To: Cranston City Plan Commission
From: Amelia A. Lavalley – Interim Planning Technician
Date: September 5, 2023
Re: **Dimensional Variance @ 252 Garfield Avenue**

Owner: Cranston BVT Associates LP
Applicant: Five Below
Location: 252 Garfield Avenue, AP 7, Lot 3649
Zone: C-4 (Highway Business)
FLU: Highway Commercial/Services

PROPOSED UNDER CANOPY SIGN RENDERING

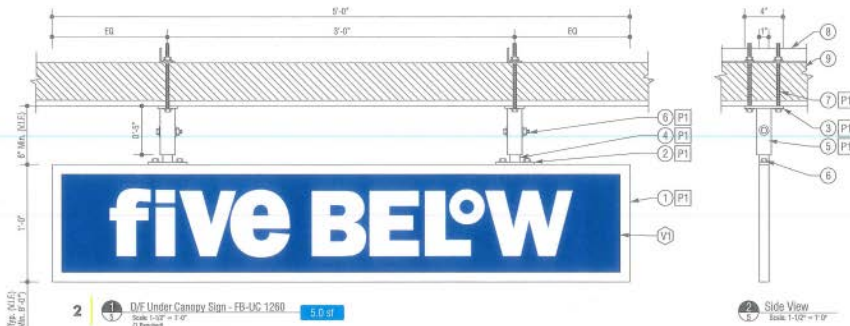
- b. To install an under canopy sign of 5 sq. ft. [17.72.010 – Signs].
 - i. It is salient to note that an “under canopy sign”, or a projecting sign that customers would walk beneath, is not explicitly defined, restricted, nor prohibited within the zoning code. According to Section 17.72.010 – Signs, projecting signs in the C-4 zone are allowed to measure a maximum of 20 square feet. Staff appreciates the addition of the under canopy sign as a dimensional request, but believes that relief is not necessary due to the fact that the proposed under canopy sign would be of an insignificant size, measuring below the maximum area (in square footage) of 10 out of 11 sign types defined in the zoning code.
